SUBJECT: BROOKHAVEN NATIONAL LABORATORY (BNL): FINAL EXPLANATION OF
SIGNIFICANT DIFFERENCES (ESD) FOR AREA OF CONCERN 9,
BROOKHAVEN GRAPHITE RESEARCH REACTOR (BGRR)

**FINAL AREA OF CONCERN 9
BROOKHAVEN GRAPHITE RESEARCH REACTOR
EXPLANATION OF SIGNIFICANT DIFFERENCES**

April 23, 2012

**Section View of Biological Shield During Removal Activities
(Typical for North, West & South Walls - Similar for East Wall)**

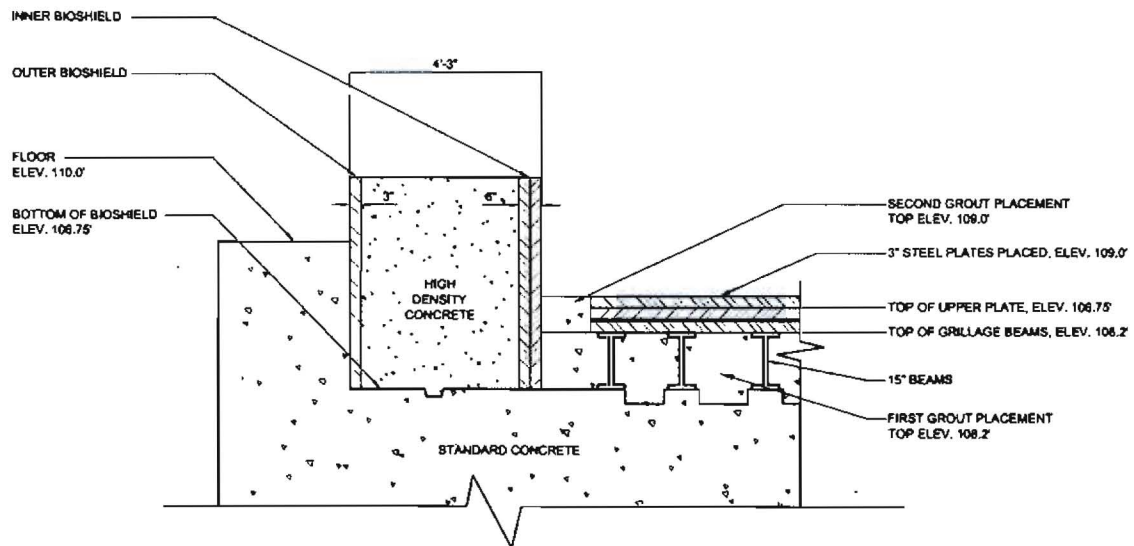
During initial phases of the biological shield removal project, a remote-operated, rail-mounted excavator with a hydraulic breaker hammer was utilized to break the concrete on the roof and sidewalls. Once the roof had been removed, and removal of the sidewalls was in progress, it became evident that this excavator/hammer unit lacked sufficient force to break the high-density concrete effectively enough to support the project schedule. The decision was made to deploy a larger excavator/hammer unit which would be capable of breaking the concrete in the walls at a higher rate. Once the new unit was selected, it was determined the building floor as well as the floor area within the footprint of the biological shield required reinforcement to support the machine, which weighed over 35 tons. To accomplish this, the void areas beneath the Building 701 high bay area outside of the biological shield footprint were filled with cementitious grout, and steel plates were placed atop this floor surface to evenly spread the load of the new excavator/hammer unit. To strengthen the floor area within the

biological shield footprint, the north and south outlet air plenums were filled with reinforced concrete. This configuration not only provided a solid, void-free surface on which to operate the new excavator, it provided additional shielding which allowed workers (including the excavator operator) to enter the interior of the biological shield for the first time in the project to perform tasks that had previously been inefficiently accomplished by remote means.

**Section View of Proposed End State
(Typical for North, West & South Walls)**

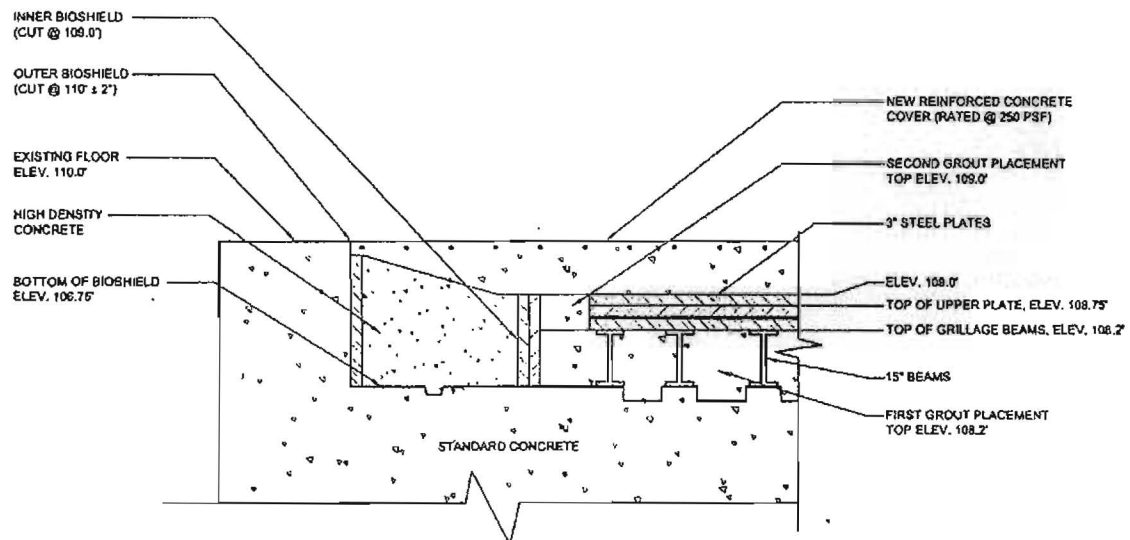
The BGRR ROD, Section 10, Selected Remedy, states "Removal of the biological shield will include the removal of the neutron shields and the steel-encased concrete walls." As stated above, the steel-encased concrete walls have a height of 33'-7" and their foundations are seated at 3'-3" below the building floor level.

DOE proposes a completed end state which is different than that described in the Selected Remedy. Removal of the biological shield inner steel wall and concrete structure will take place at least to the existing Building 701 floor level. This change would leave approximately 650,000 lbs of concrete (approximately 8.8% of the biological shield concrete by weight) and 80,000 lbs of activated steel (approximately 4.0% by weight) in the foundation of the walls, with a total residual activity of approximately 1.1 Curies. In addition, one of the two remaining steel bed plates that supported graphite pile and was planned to be removed will remain in place containing approximately 9.8 Curies. This remaining activity is additional to the amount specified in ROD (2005) for the end state of selected remedy. Approximately 80 – 90% of this additional activity is attributed to Ni-63 decay with the remainder due to the decay of Am-241, Co-60, Fe-55 and other radionuclides. The outer steel walls, which are free of radiological activation, will also be removed to the existing floor level, leaving the foundation below the floor. The portion of the biological shield foundation remaining below the building floor will be protected beneath a reinforced concrete cover. The steel plates that were placed over

the pile bedplates and cementious grout installed during the removal activities will also remain in place beneath the reinforced concrete cover. This will provide for a structurally stable long-term configuration, with no void spaces, no pathway to groundwater for radioactive contaminants, and radiological dose rates less than 0.1 milliRem per hour (mR/hr). This change in end state does not affect the planned long-term surveillance and maintenance activities for Building 701.
